Aviation DOA Nr.: EASA.21J.025	<b>Service Information</b>	Dokument Nr.: <b>SI-AT01-018</b>
	<b>Laufende Modifikationen/ continuous modifications</b>	Ausgabe/Issue: A.18 Seite/Page: <b>1 of 2</b>

## Service Information SI-AT01-018

#### A-2 Subject:

Continuous modifications and changes to parts and appliances are cumulatively detailed and published within this SI.

Aviation DOA Nr.: EASA.21J.025	<b>Service Information</b>	Dokument Nr.: <b>SI-AT01-018</b>
	<b>Geänderte PIN-Belegung UMA - Tankanzeige/ <i>changed pin configuration UMA – fuel gauge</i></b>	Issue: A.01 annex 1 (english)

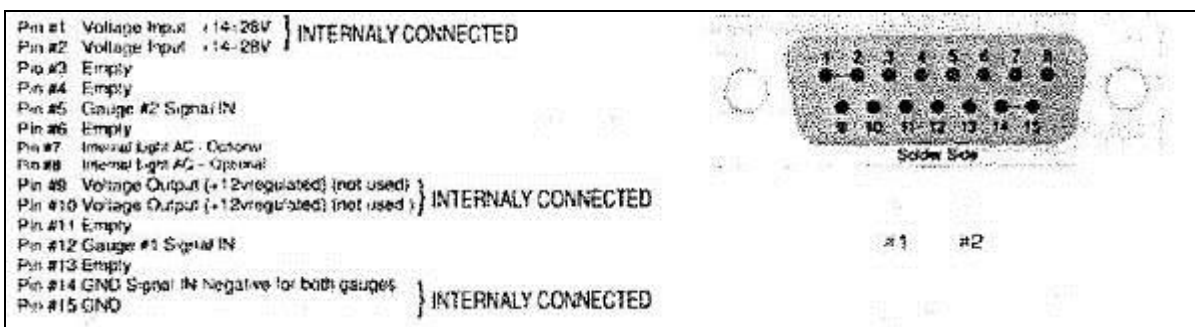
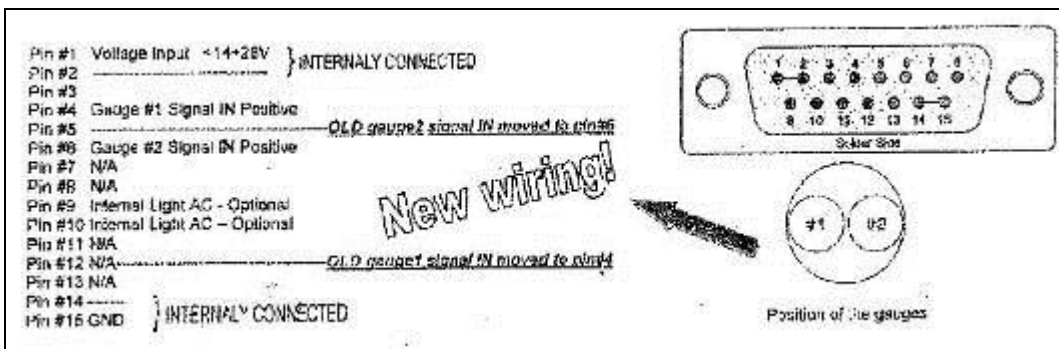
The manufacturer of the fuel gauges has changed the pin assignment without changing the P/N. The old pin configuration is no longer available, therefore the connector has to be soldered new and compatible when a fuel gauge exchange is performed.

**Note:** After installation of a new fuel gauge calibration to zero at unusable fuel in both tanks has to be checked (reading slightly below “E”, not above).

connection	PIN – old (AT01-2840-206)	PIN – new (AT01-2840-220)	cable-marking
supply 14-28V	1	1	8041Z20
GND	15	15	8041Z20N
L+	12	4	8041AL22s-wh
R+	5	6	8041AR22s-wh
L-	11	14	8041AL22s-wh/bu
R-	4	14	8041AR22s-wh/bu

Aviation DOA Nr.: EASA.21J.025	<b>Service Information</b>	Dokument Nr.: <b>SI-AT01-018</b>
	<b>Umrüstung Aviasport auf UMA - Drehzahlmesser/ Retrofit from Aviasport to UMA – tachometer</b>	Issue: A.01 annex 2 (english)

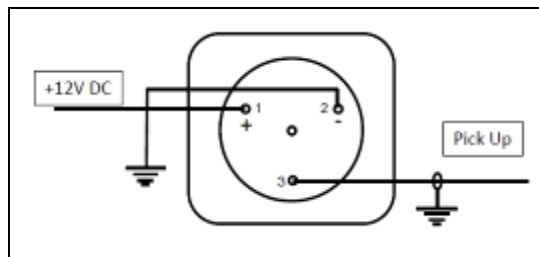
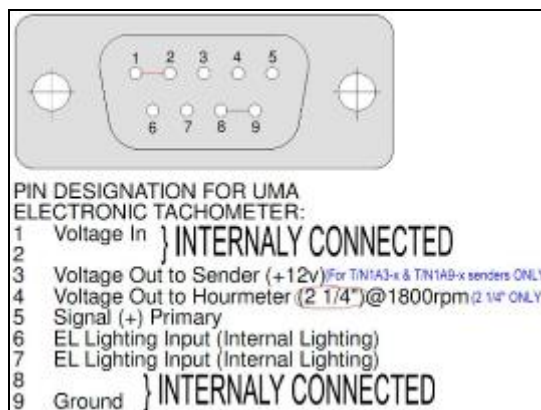
In case of necessary exchange of Aviasport tachometer (7030-100) a retrofit to a UMA tachometer (7030-103-R00) is recommended.

Therefore the connecting plug has to be crimped new and compatible.

**Note:** After installation of the tachometer the accuracy of the gauge has to be checked with an optical revolution counter ( $\pm 30$ rpm).

connection	PIN – old (AT01-7030-100)	PIN – new (AT01-7030-103-R00)	cable-marking
supply ( + ) 12V DC	1	1	7035A20
GND ( - )	2	9	7035A20N
signal ( + )	3	5	7035B22s-wh

figure 1: improved engine control quadrant (7020-001-010-R01)

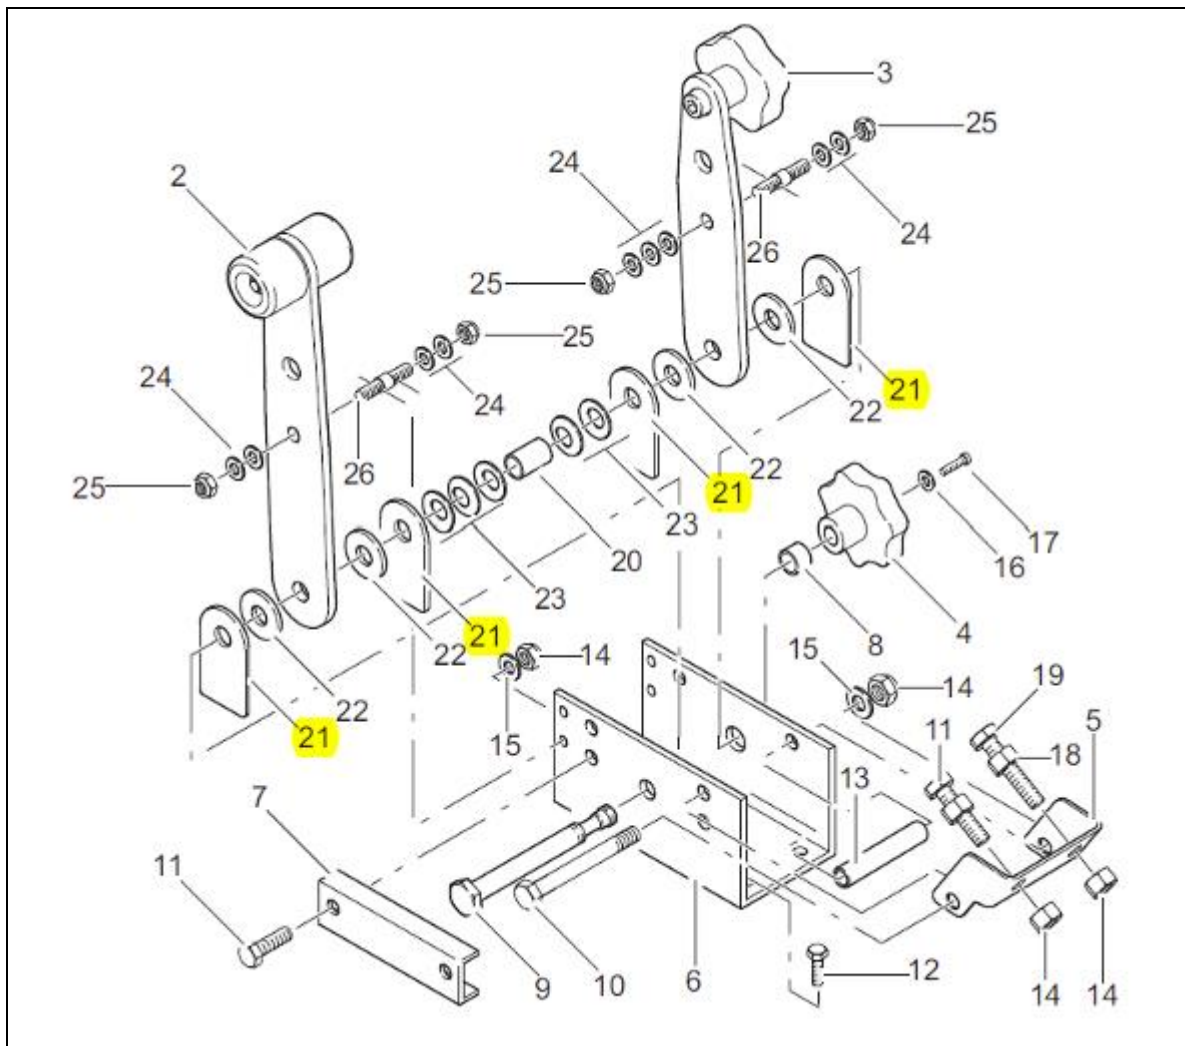
In case of necessary exchange of the engine control quadrant (7020-001-010) an improved version (7020-001-010-R01) is recommended.

The improvement consists of four metal sheets (7020-145-R00), which prevent a co-rotation of the throttle or propeller-pitch control lever.

Also a retrofit (see figure 1, position 21) is possible, if the 4 washers (DIN9021 8,4x24mm) are replaced by the four metal sheets (7020-145-R00).

### alternative nose landing gear axle bolt / bearing races / axle

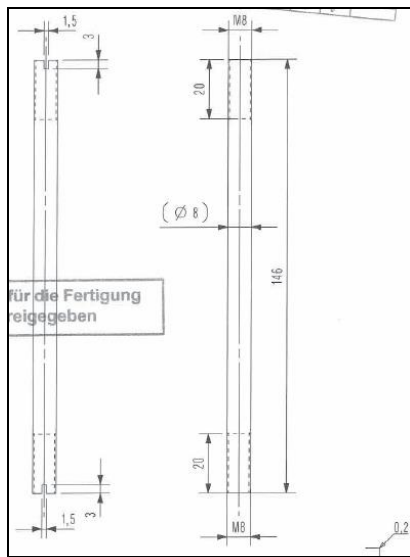
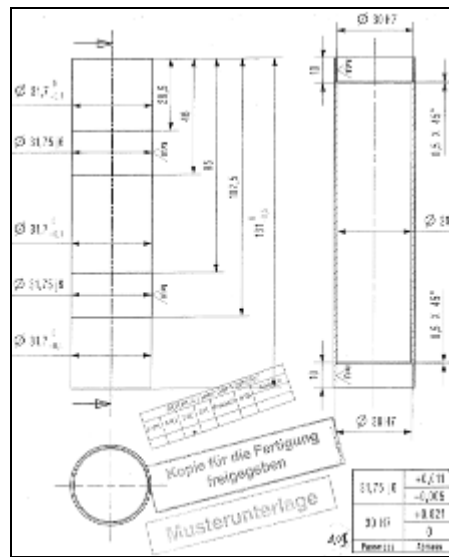
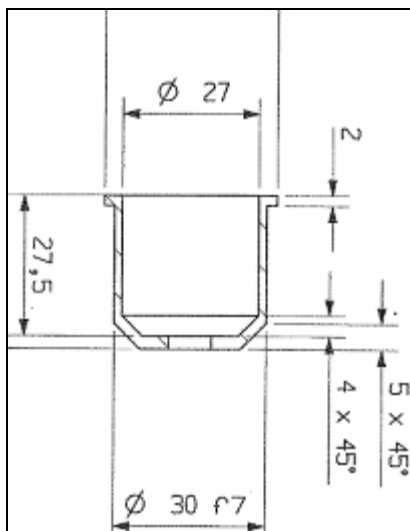
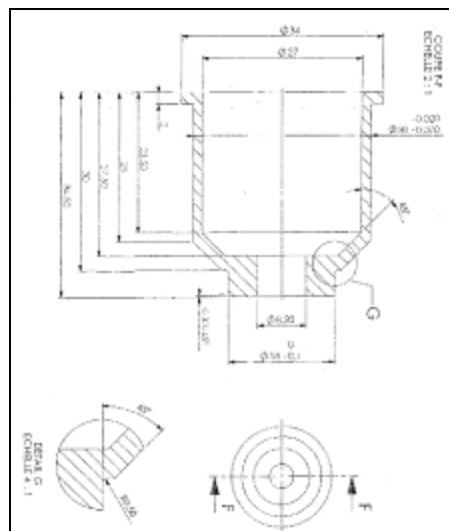
Installation of a 4 mm shortened axle bolt (5150-123) besides the standard axle bolt (5150-103), the Beringer bearing races (5150-131) besides the standard bearing races (5150-101) and a stainless steel axle (5150-100-R01) besides the standard axle (5150-100) for Groove und Cleveland nose landing gears.

### advices for the battery mount

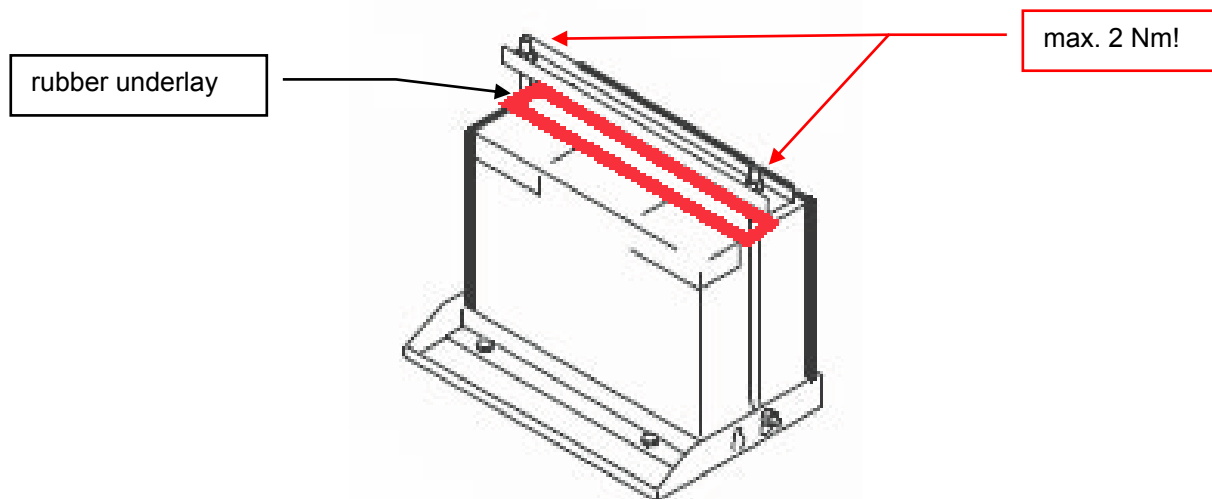
To avoid mechanical damage to the battery a rubber underlay 1,5x175x15mm (glued with double-faced adhesive tape to the aluminum U-profile) between the battery hold down bracket (Al-U-profile) and the battery is recommended.

Also the recommended torque for the self-locking nuts at the hold down bracket is **max. 2Nm**.

rubber underlay 1,5x175x15mm (AQUILA P/N. **4540-134-R00**)

firewall AQUILA AT01 model AT01 and AT01-100

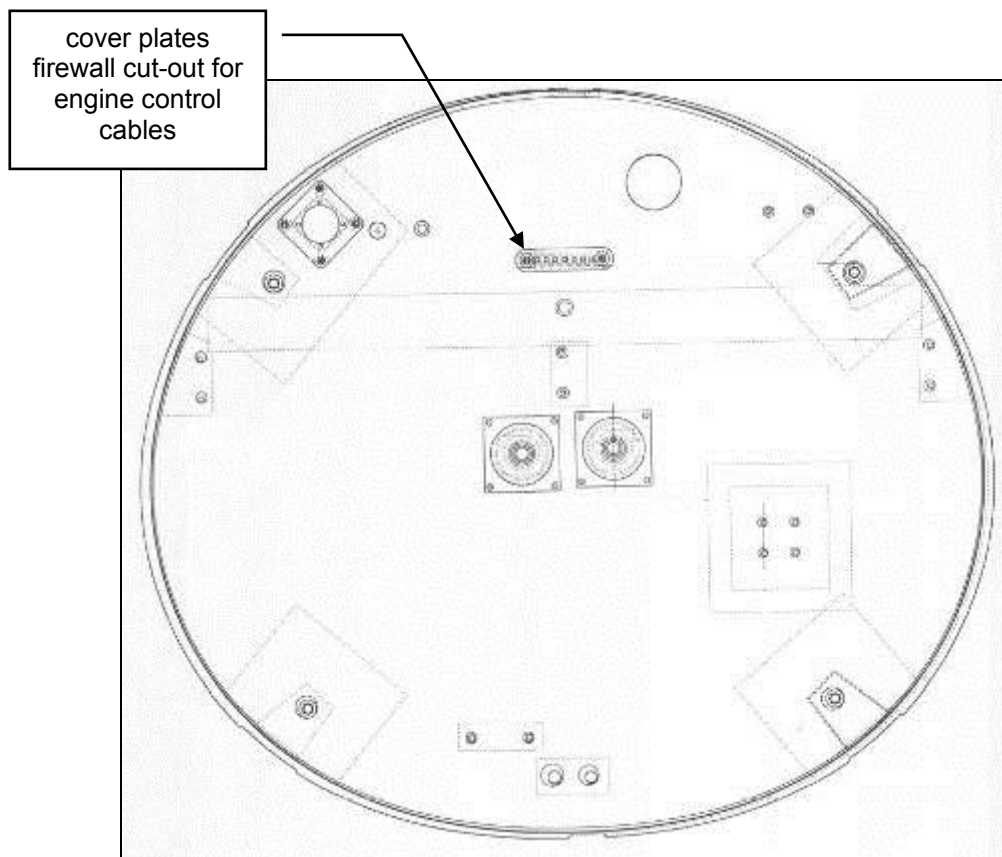
In case of increased friction or friction induced noise within the engine controls (throttle, propeller- or choke lever) it is a possible cause that the cover plates at the firewall cut-out have cut into the casing of the engine control bowden cables.

Therefore an exchange with thicker plates (1,0mm) is recommended.

2x cover plate engine control cables 1,0mm (AQUILA P/N **2120-134-R01**)

## Retrofit of a capacitor for the external generator

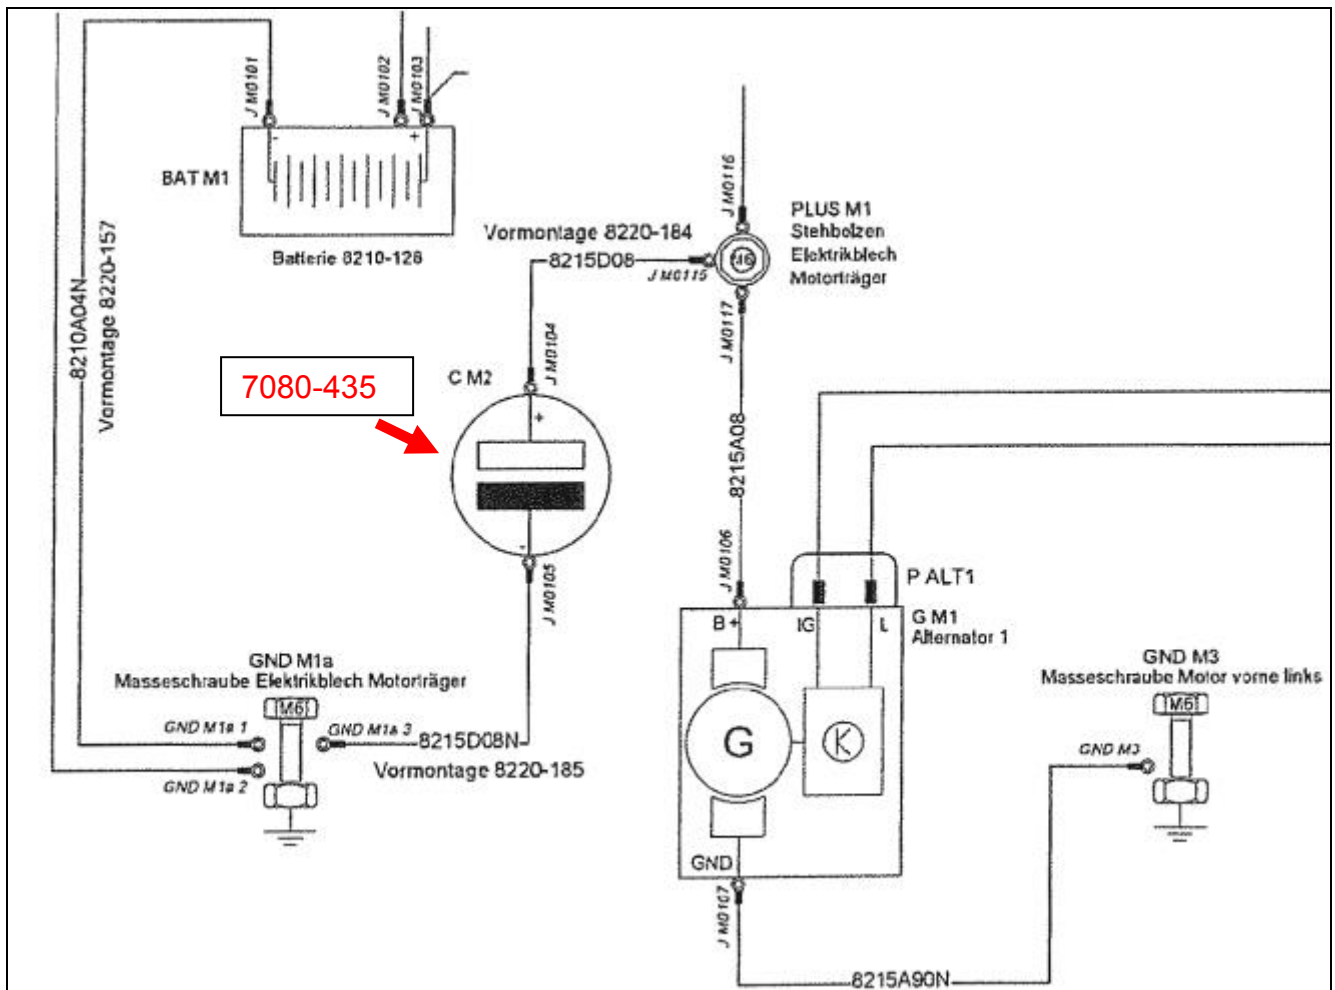
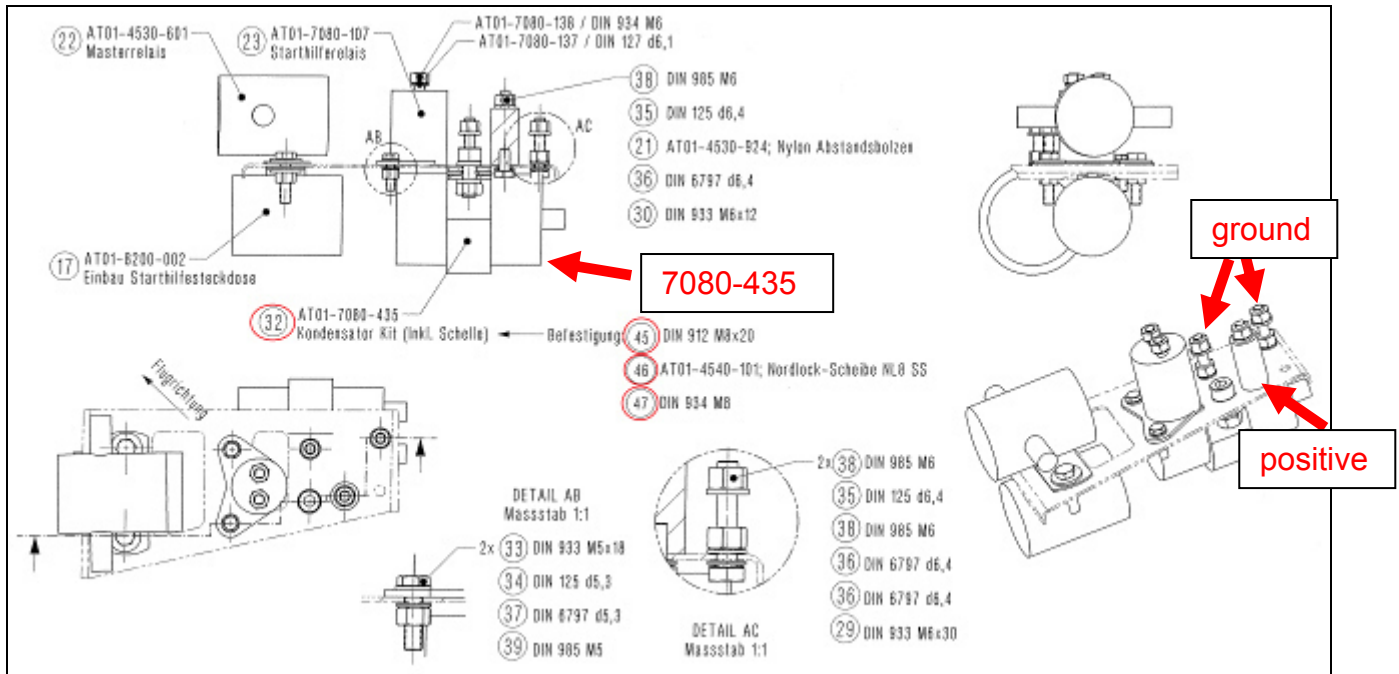
To minimize interference induced by voltage fluctuations, retrofit of a capacitor for the external generator is recommended.

- electrical connection according wiring diagram:

- mechanical connection onto electrics holding plate at engine mount depending on version as far as possible according to drawing:

- 1x ROTAX capacitor; 22.000 mF 25V (Rotax P/N 966590Z; AQUILA P/N **7080-435**)
- 1x pipe clamp with rubber section, range 50mm/ band 20mm (AQUILA P/N **4520\_RSGU1.50/20W1**)
- 1x connecting cable Positive (AQUILA P/N **8220-184**)
- 1x connecting cable ground (AQUILA P/N **8220-185**)
- fastening elements as required

### alternative dual dimmer

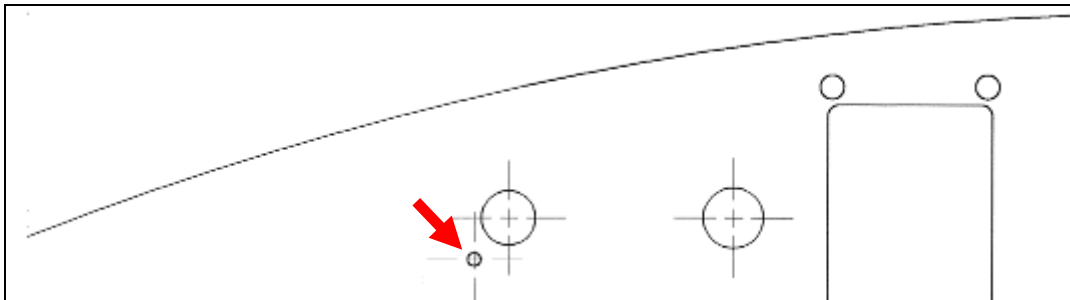
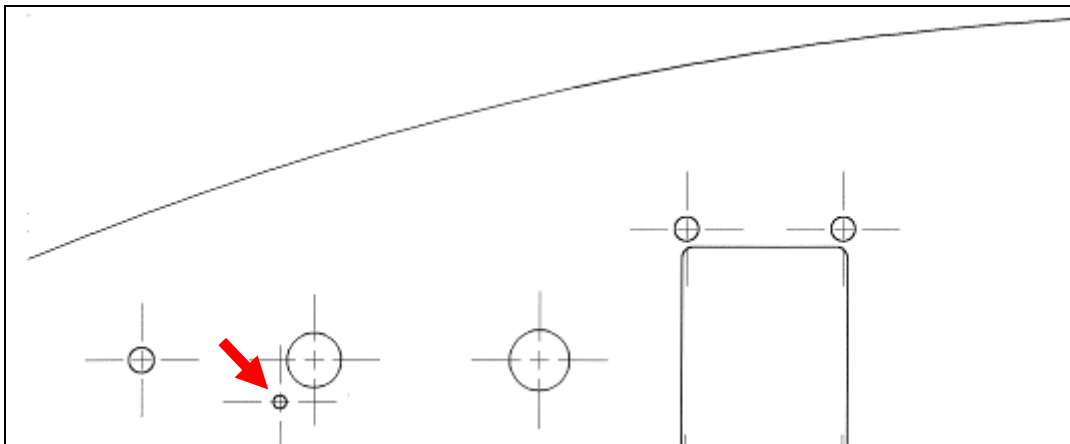
The former type of dual dimmer is no longer available.  
An equivalent substitute is herewith approved for installation.

If retrofitting **4530-673** with **4530-673-R01** a  $\varnothing$  2,5mm blind hole approx. 1mm deep for the anti-rotation pin according to the sketch below, approx. 5mm left below the existing bore (instrument panel from behind), is required.

**new:** MaxDim Micro Dual Control Unit (AQUILA P/N **4530-673-R01**)

### 0,20mm fuel return line restrictor instead of 0,25mm

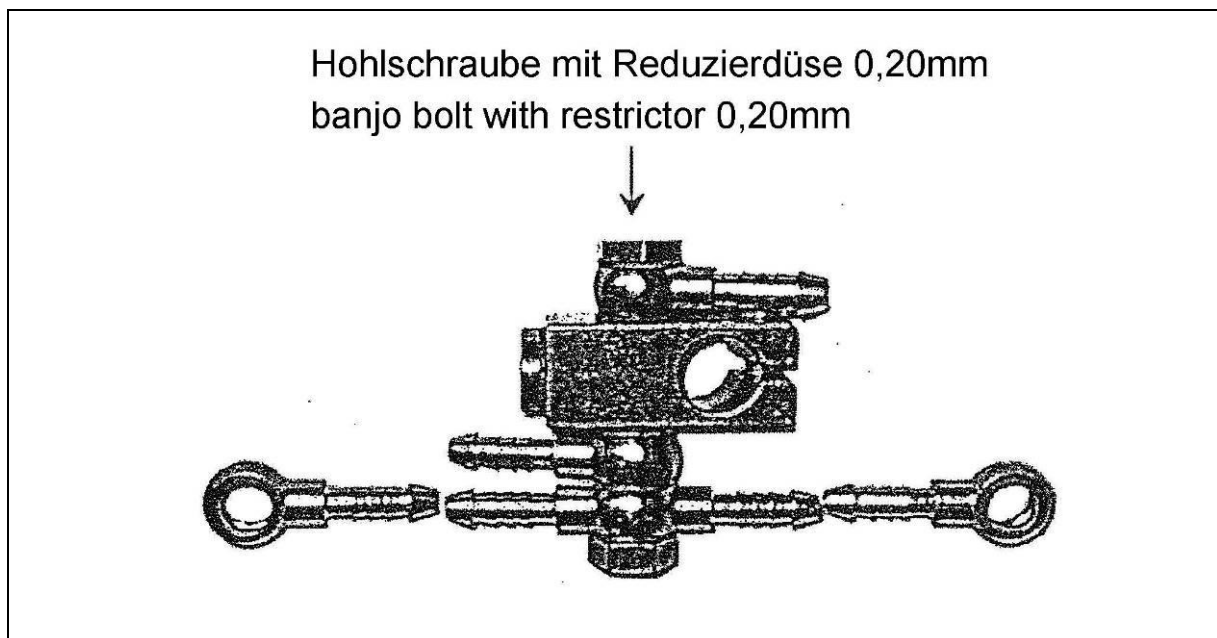
With introduction of the mechanical fuel pump P/N 893115 by Rotax in some cases, in particular when switching off the electrical auxiliary fuel pump, the fuel pressure warning light illuminates (fuel pressure below 0,15bar).

This is uncritical if the warning duration is below 10 seconds.

To eliminate these short term fuel pressure drops, the fuel return line restrictor may be replaced.

Remove „0,25“ marking at banjo bolt head and apply „0,20“ marking clearly visible.

Check fuel pressure during ground run at power change from idle to full throttle with and without electrical auxiliary fuel pump.

**new:** 1x Franz idling injector LD20 (AQUILA P/N **8020-104**)
